## ADDENDUM NO. 2

Modernize Elevator  
Sexual Offender Rehabilitation Treatment Services (SORTS)  
Hoctor Building  
Farmington, Missouri  
PROJECT NO. M1814-01

## REAR DOOR INFILL ELEVATION

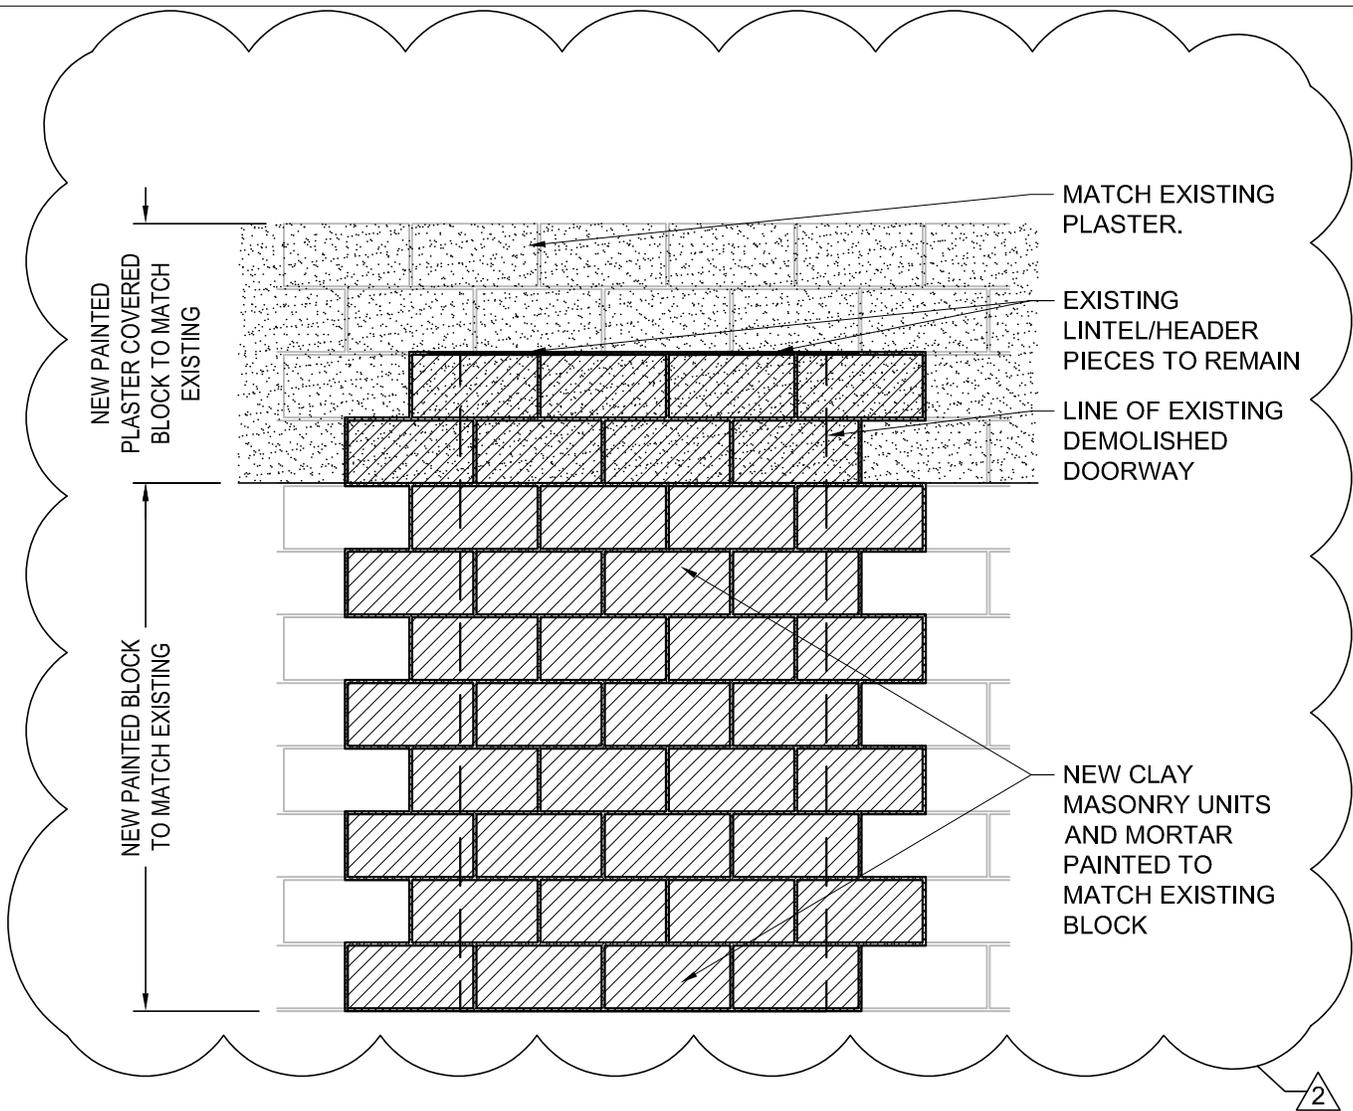
a. REMOVE and REPLACE Detail 3/A-102 with attached revised Detail 3/A-102.
